Product Change Notice (PCN)

PCN Number: PCN-0381147R-01

Product(s) Affected: *CLS0281MAE-L152*

Before	*After*

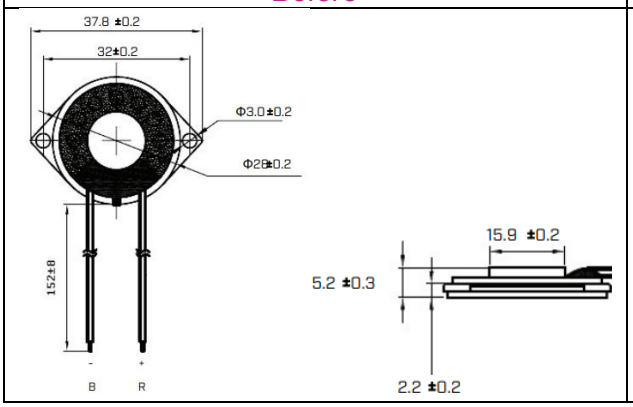
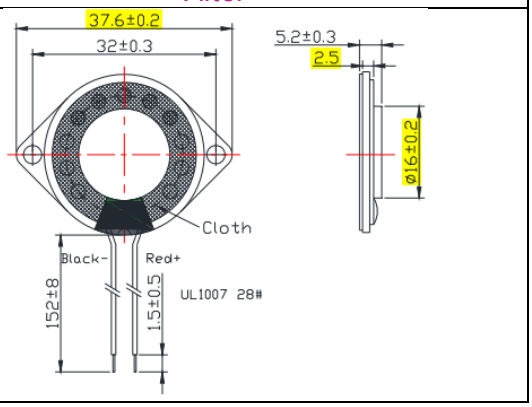
Description of Change: *Operating temperature extended to -20° ~ +70° & minor alterations to the magnet size and external frame length, see below diagram for measurement changes.*
